6563 River Clyde Dr.

Highland Lake Lot 97

BP on Hold-upgrading a 4 Bdrm House to a 5 Bdrm c limited SDA (Reduced by prior Swim Pool Addn)

Lot 7B

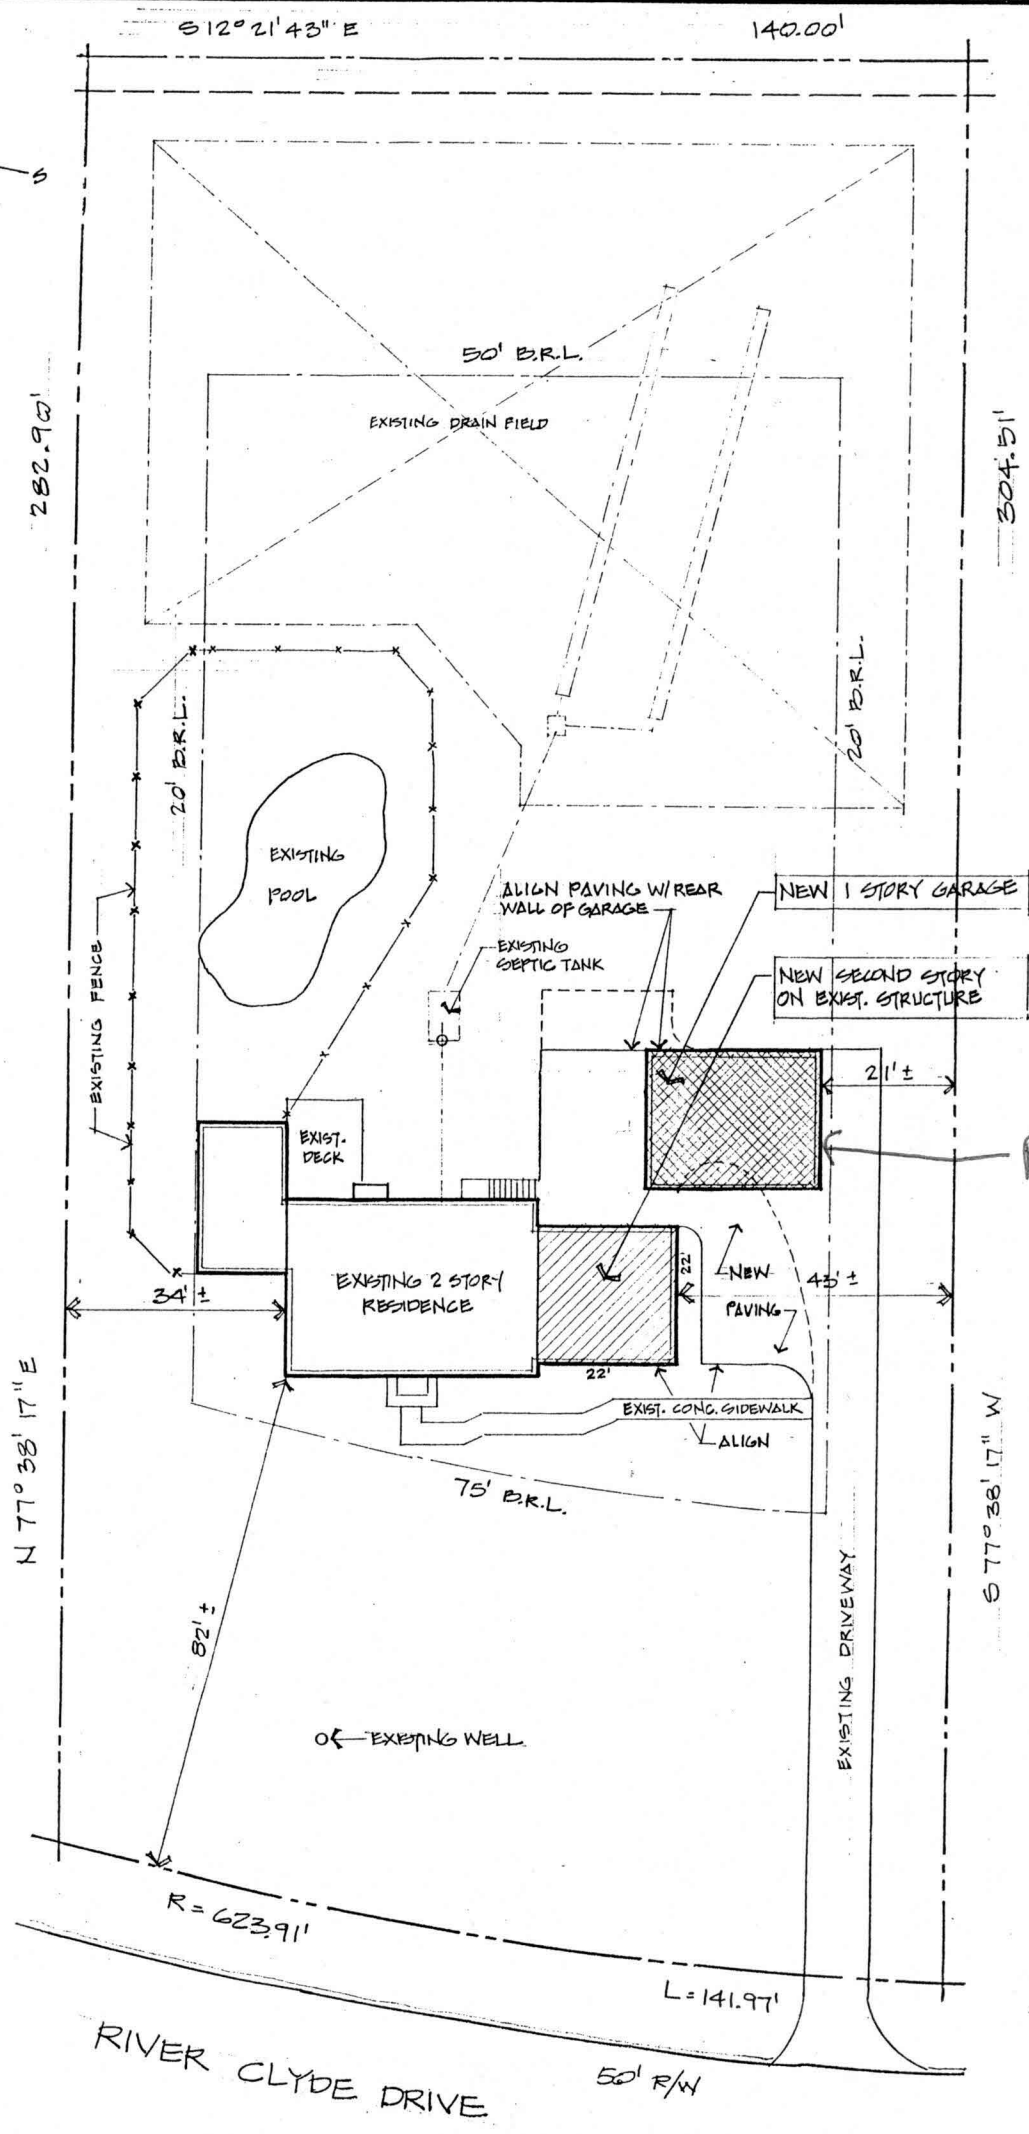
11/8/00
proposed
garage has
no impact to
well or
septic
OK SRU

5/6/98
 EXISTING PAV
 APPROVED
 PATIO TO
 BE REPAIRED &
 ENCLOSED
 NO IMPACT
 TO WELL OR
 SEPTIC.
gld jw

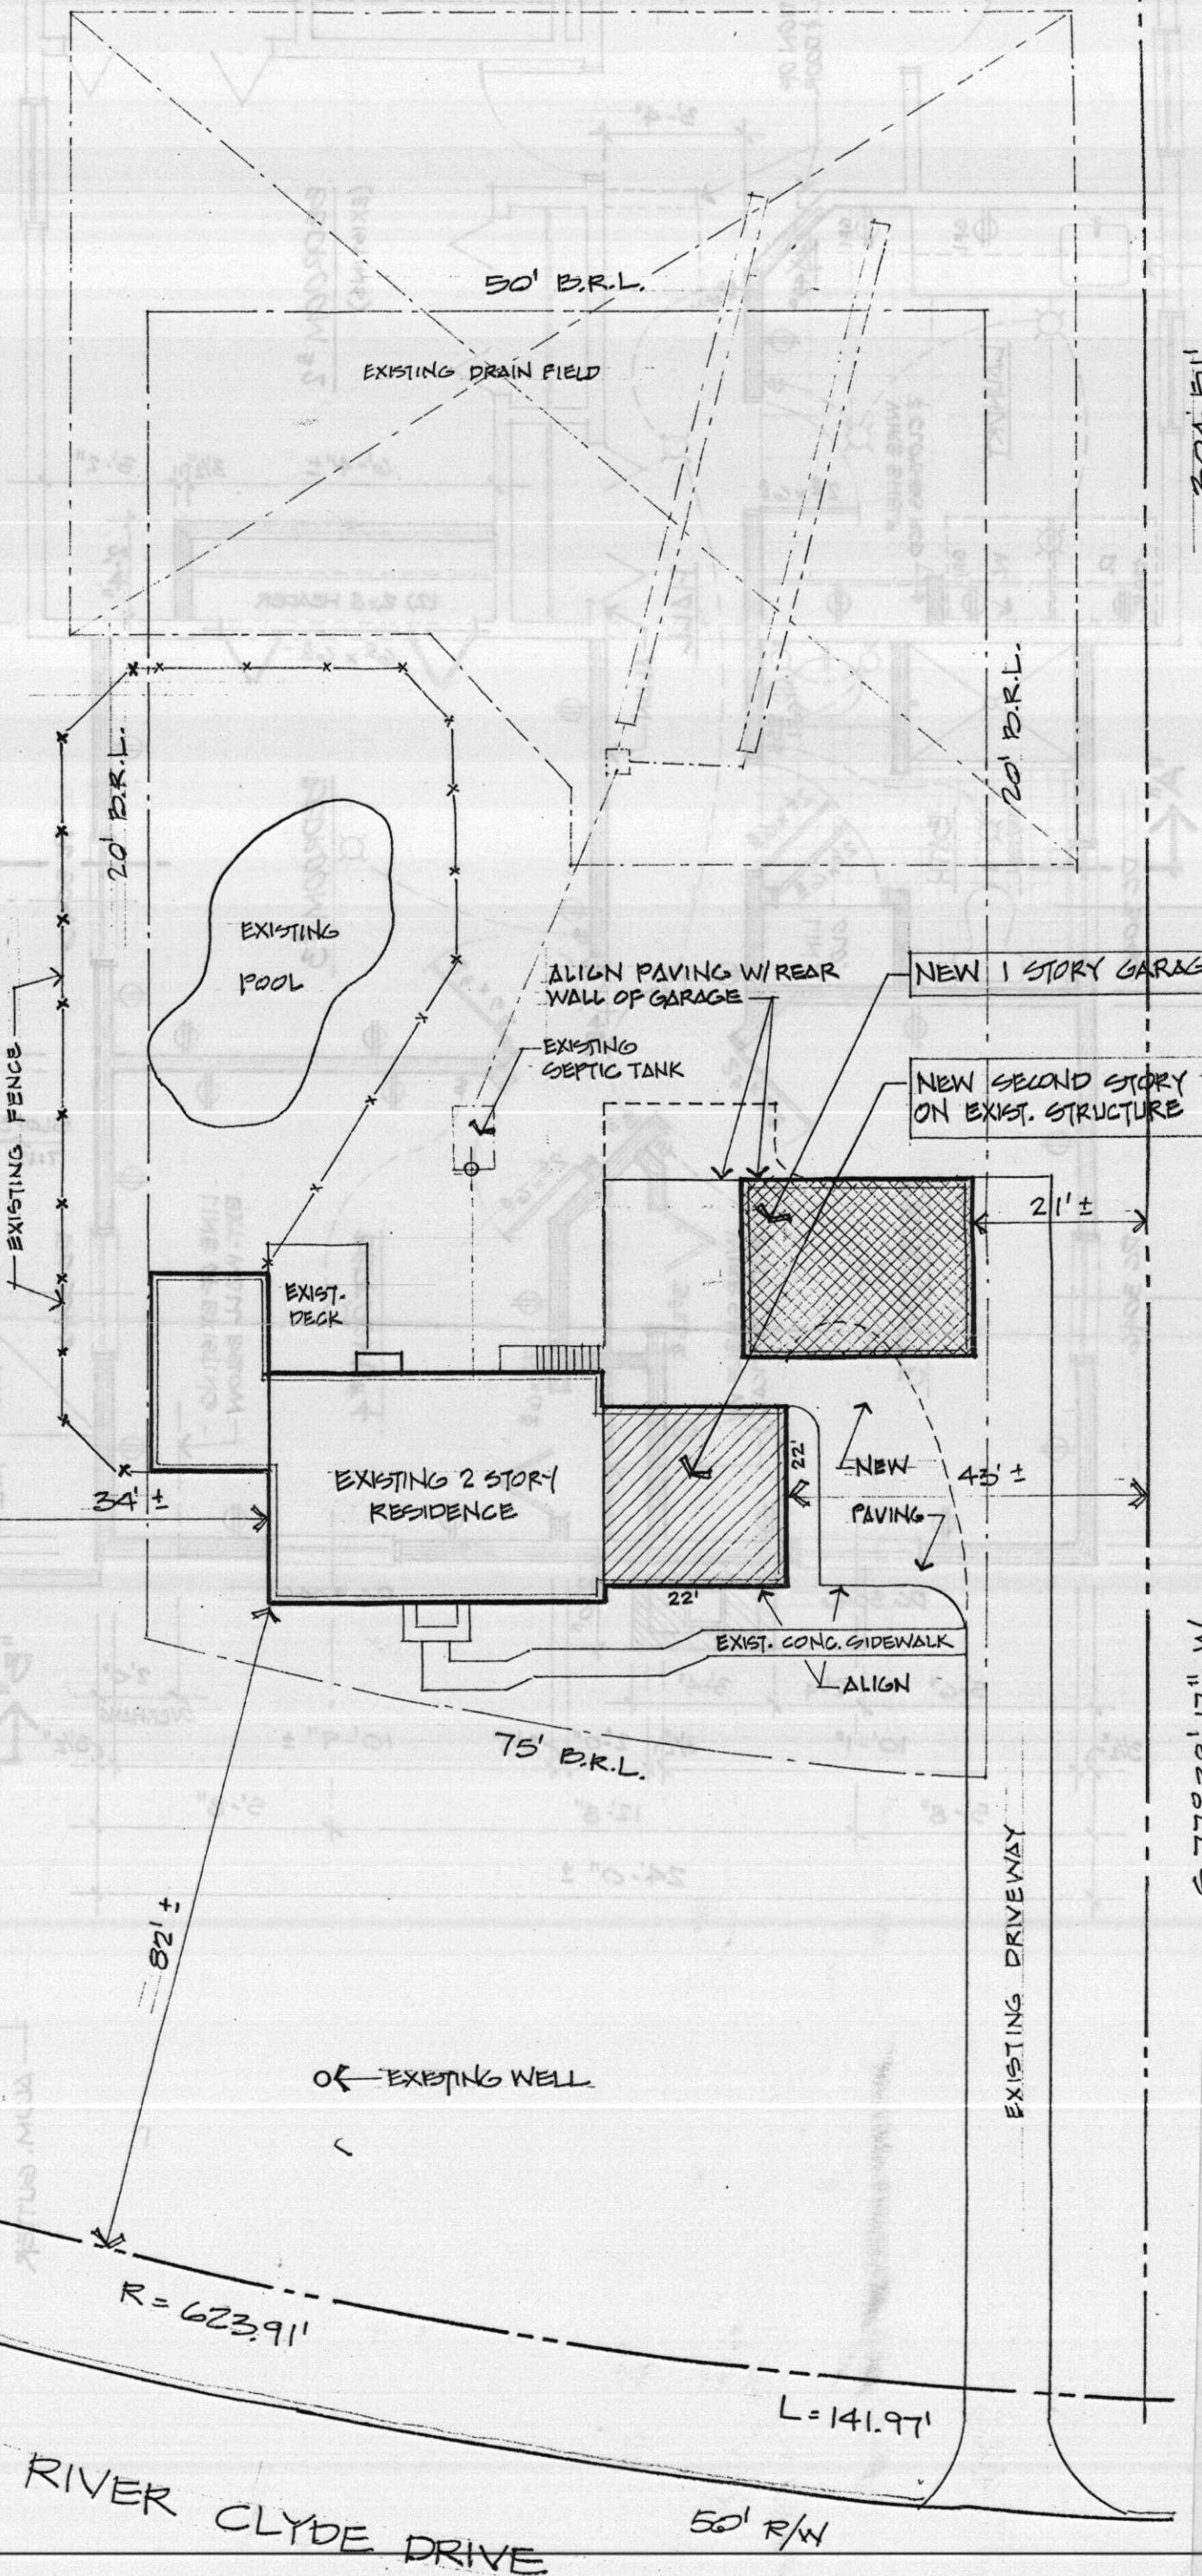
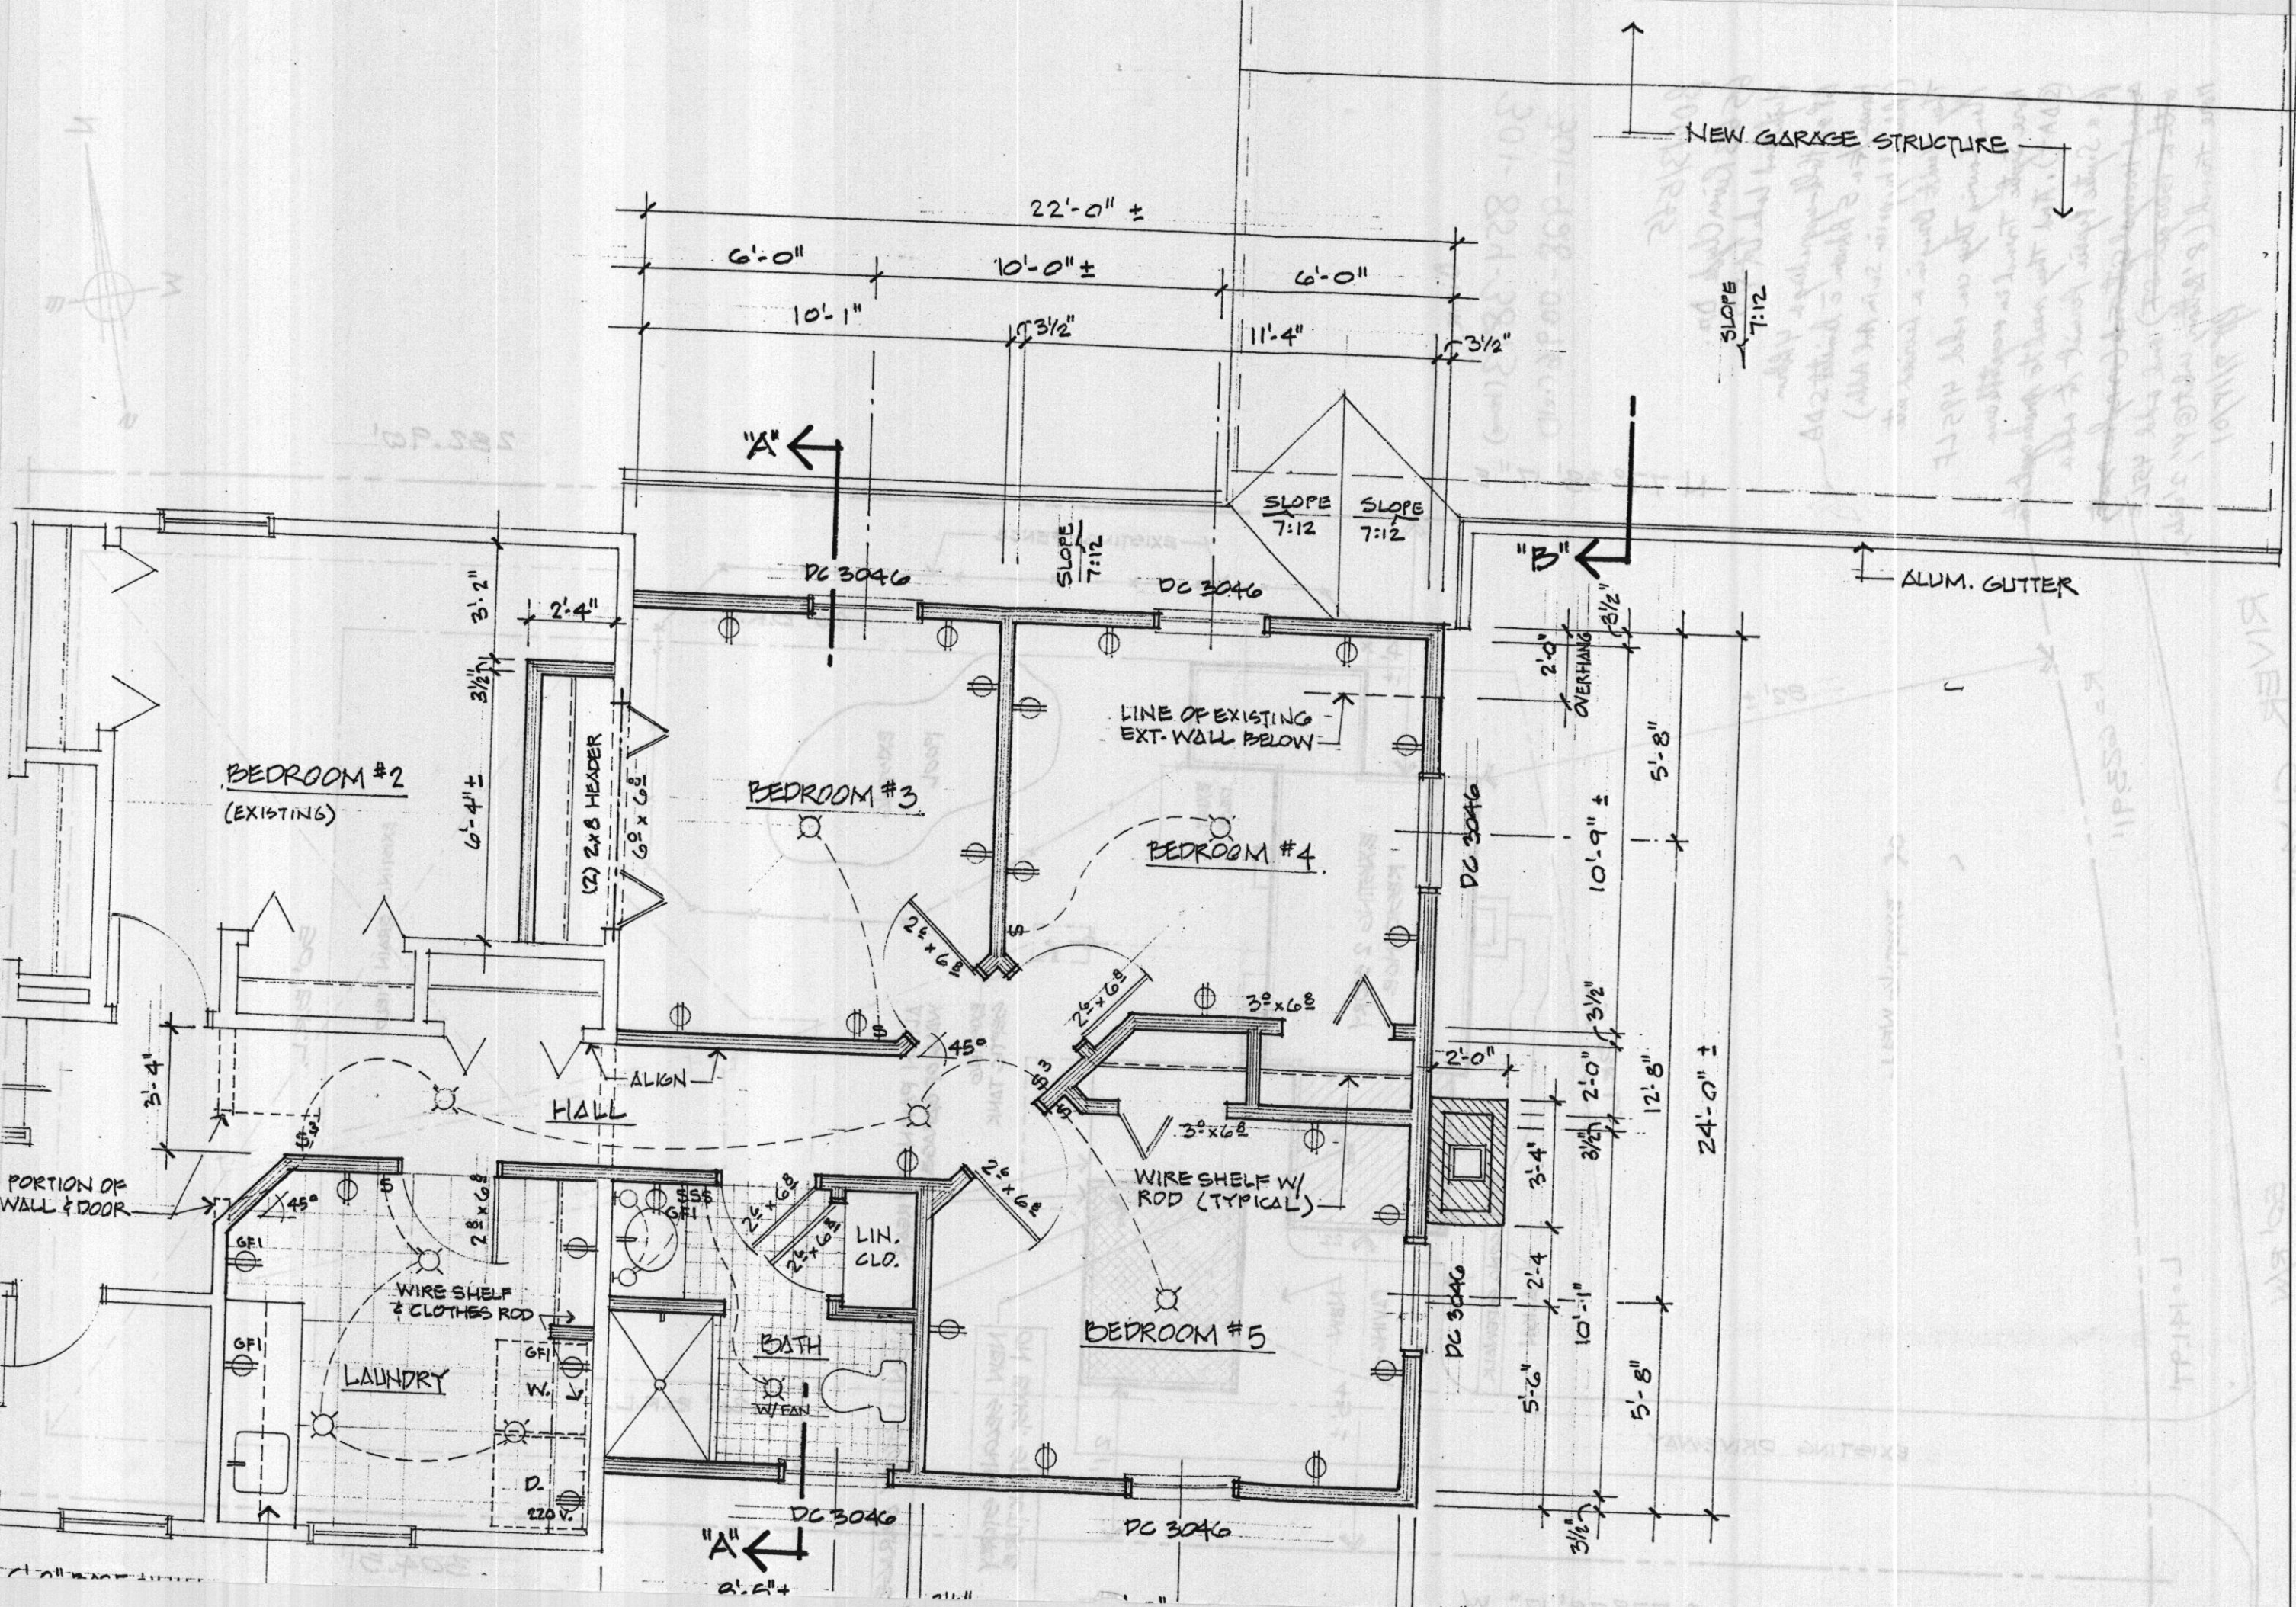
They Need to Bring in a Revised site

Plan Showing they can add 495 LF

More Septic Trench in acceptable area

(SDA+). And They need to make application

for a Septic Repair Permit to add a

second 1000 gal Septic Tank (or replace existing

with a 1500 gal ST) and add 45 LF

More Trench (8' Bottom, inlet @ 4', 2' wide).
